Mosqueda Community Center - Exterior  
4760 East Butler, Fresno

Mosqueda Community Center (MCC)

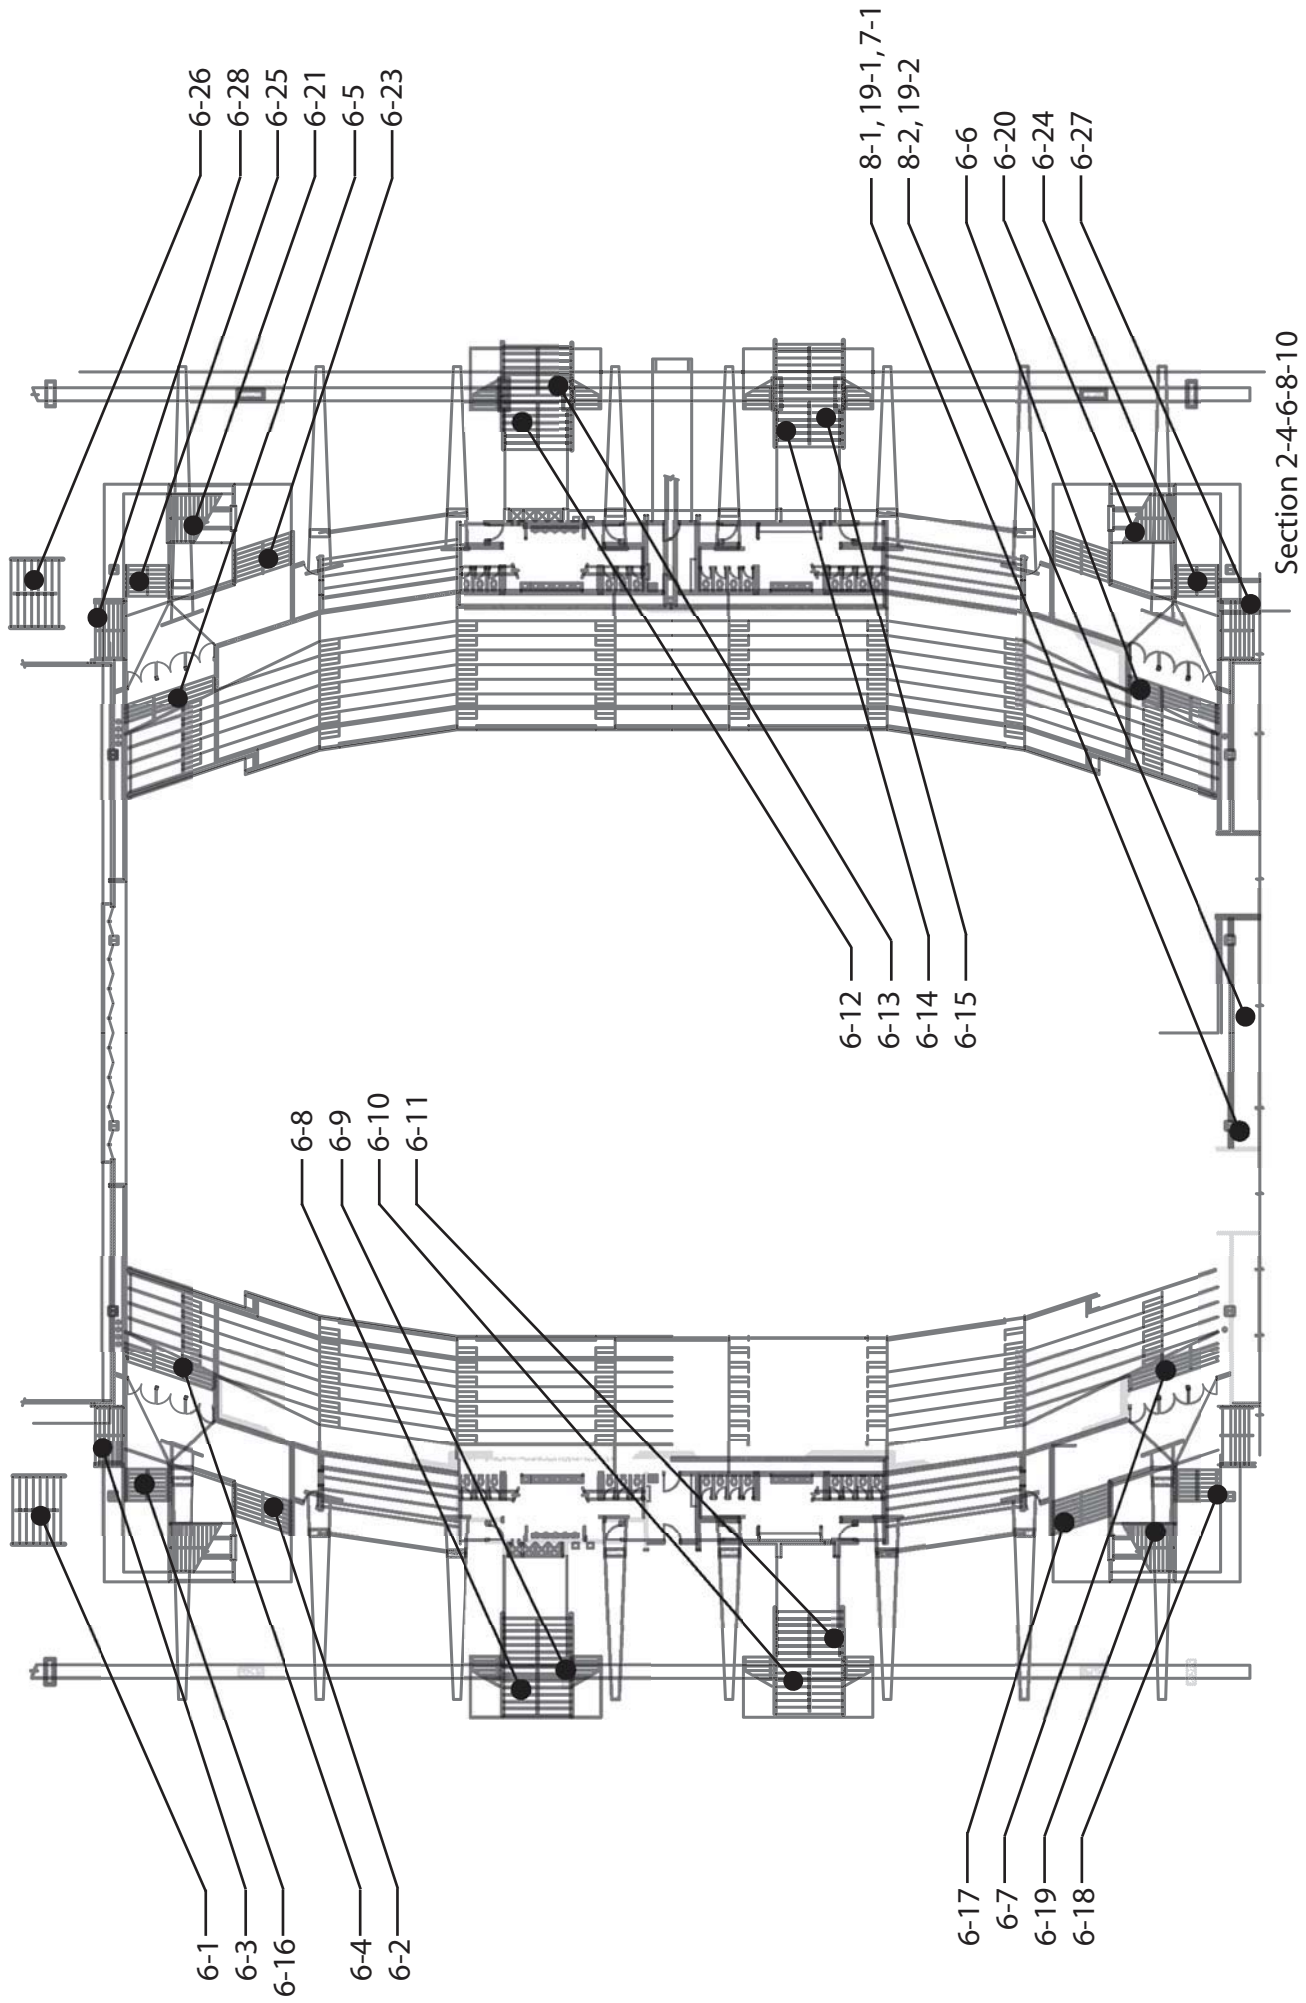
<b>Floor 2</b>	
<b>19 - 2 Multiple User Restroom</b>	<b>Priority:2</b>
<b>Install sign</b>	<b>\$250</b>
Notes: Sign is not appropriate 12" circle. Braille is not provided. Accessible facility is not identified with Int'l Symbol of Accessibility.	
State: 1115B.6, 1117B.5.1 #1, 1117B.5.5 #3, 1117B.5.8.1.2	
Federal: 4.30.4	
<b>Modify lavatory/counter clearances</b>	<b>\$1,500</b>
Notes: Space under bowl is 26" (27" min.).	
State: 1115B.4.3 #2	
Federal: 4.19.2	
<b>Provide or replace stall door hardware</b>	<b>\$200</b>
Notes: Handles not provided on front and back of stall door.	
State: 1115B.3.1 #4.5	
Federal: 4.13.9	
<b>Modify stall partitions and doors</b>	<b>\$2,300</b>
Notes: Door width is 22-1/2" (32" min.). 18" from edge of toilet to partition wall (32" min.). 33" in front of toilet (48" min.). Stall width is 33" (60" min.).	
State: 1115B.3.1 #4.1, 1115B.3.1 #4.4, 1115B.4.1 #1	
Federal: 4.17.3	
<b>Replace toilet or adjust toilet seat height</b>	<b>\$200</b>
